Appendix 1: The Government of Yukon's comments on
the Coastal Plain Oil and Gas Leasing Program Draft
Environmental Impact Statement

Provided below are comments as well as technical and scientific evidence compiled by the Government of Yukon in response to the Coastal Plain Oil and Gas Leasing Program draft Environmental Impact Statement (draft EIS) that the Bureau of Land Management is undertaking to implement the leasing program pursuant to the Tax Act (Public Law 115-97, Dec. 22, 2017).

Figure 3 – Porcupine caribou calving varies annually as a result of changing snow conditions on the Coastal Plain. Here we provide 4 examples of years when Porcupine caribou calved further west than the “primary calving habitat area”. In several cases this includes the core calving area used by

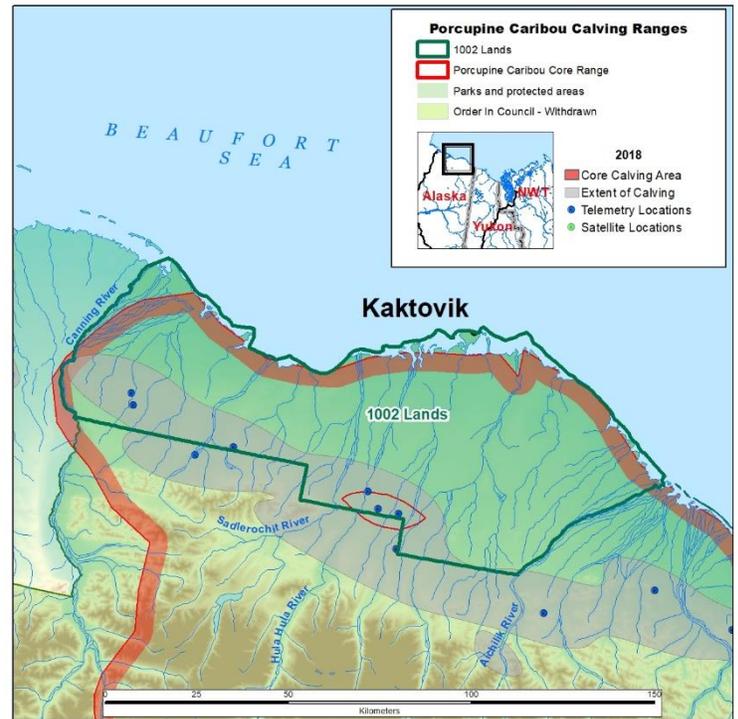
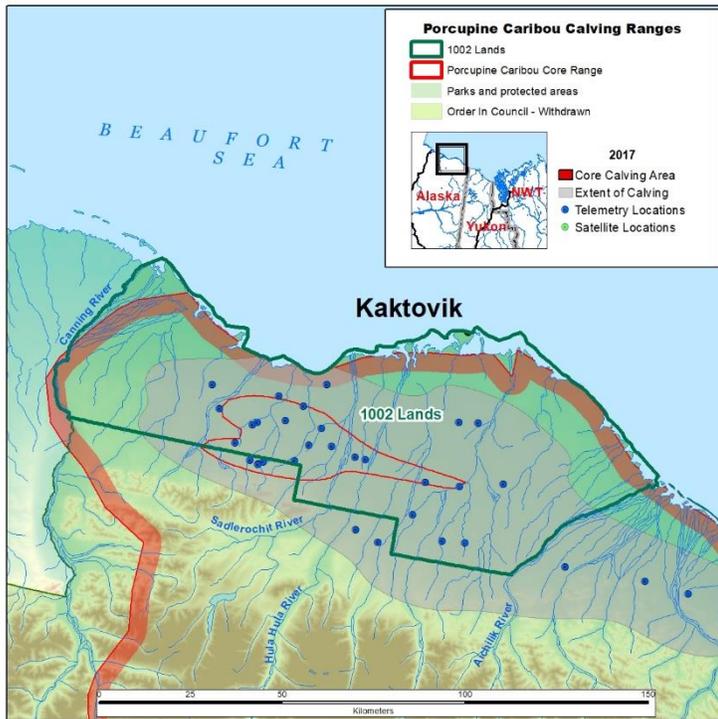
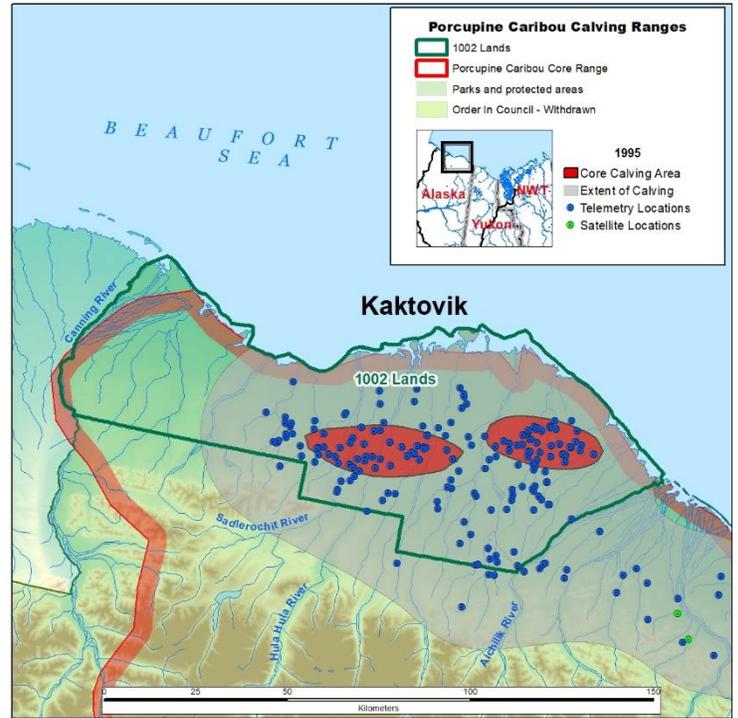
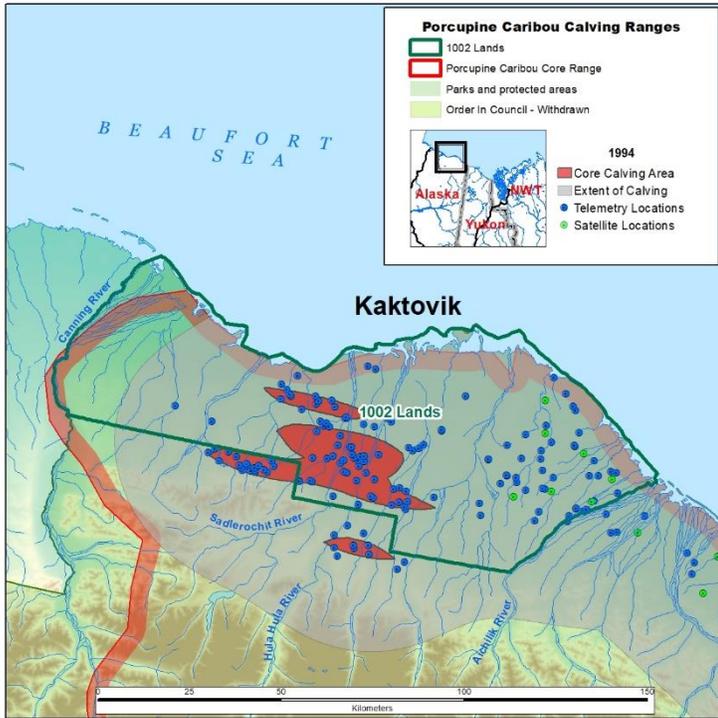
Lastly, the selection of the 40 percent of years contour to define the area that Lease Stipulation 7 applies to appears to be arbitrary (see draft EIS, Section 3, page 114). The basis of most caribou mitigations include Alternative D. No leasing and no surface occupancy are chosen based on the “primary calving habitat area”. In particular, the use of no leasing areas is solely based on this parameter. However, an area that on average is used every third year (i.e., the 33 percent of years contour) is almost as important as one used on average every 2.5 years (i.e., 40 percent of years contour). The draft EIS selection of the 40 percent of years vs the 33 percent of years contour is not explained. It is unclear if the selection of the 40

percent of years will achieve effective conservation of calving. A simple review of the total acreage of each of these contours shows that selection of approximately 30 percent of years would meet the Public Law 115-97 leasing minimum requirement of 800,000 acre (see draft EIS, Section 3, page 114). The selection of the contour area for 30 percentage of years will minimize the “unavoidable adverse effects from the proposed oil and gas activities” (see draft EIS, Section 3.5) and support all Parties in meeting PCH conservation obligations. Similar selection issues are noted for the post-calving period (Lease Stipulation 8).

the herd in that specific year. Under Lease Stipulation 7, these caribou would have had no specific protections.
